COBRA Guidance Note

The revised COBRA Scrubber / Hot Water Housing Body Upgrade Kit (Part No. DB5002505) features a seamless liner which removes the risk of hot water entering the breathing loop.

COBRA Bailout System

Figure 3 - Scrubber Housing Assembly

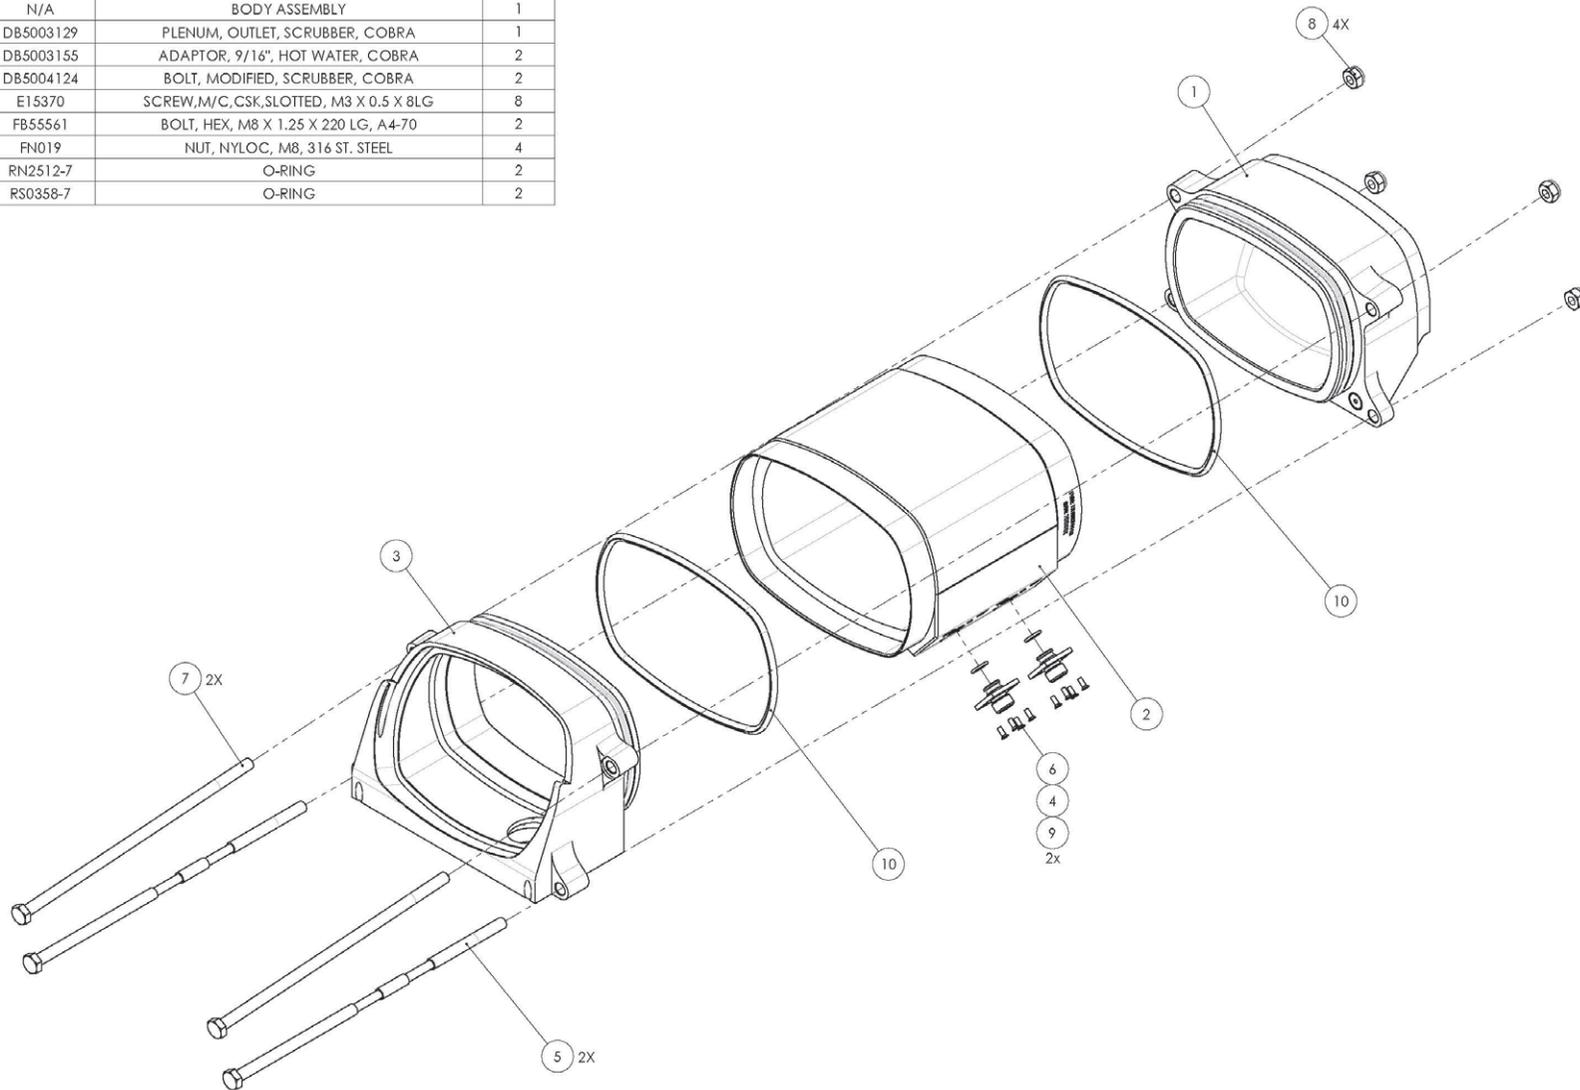
After an incident where a COBRA set flooded due to hot water entering the scrubber housing, JFD have made the decision to replace the current sectional scrubber liner with a seamless item. It is also necessary to replace the hot water jacket around the liner. This Guidance Note contains the fitting instructions for the upgrade kit.

Additionally the revised COBRA Scrubber / Hot Water Housing Body allows dis-assembly of the hot water jacket to allow cleaning by the user.

11. Use the revised long tie-bars supplied with the upgrade kit. Using two 13 mm spanners fit the tie-bars to the housing. Torque the nylock nuts to 20 lbf/in / 2.2 Nm.

- Removed parts may be recycled, refer to Table 2 below.
- It is not intended that the revised hot water jacket is fully sealed. A small amount of hot water (<0.5 L/min) will leak to the exterior of the set when in use.
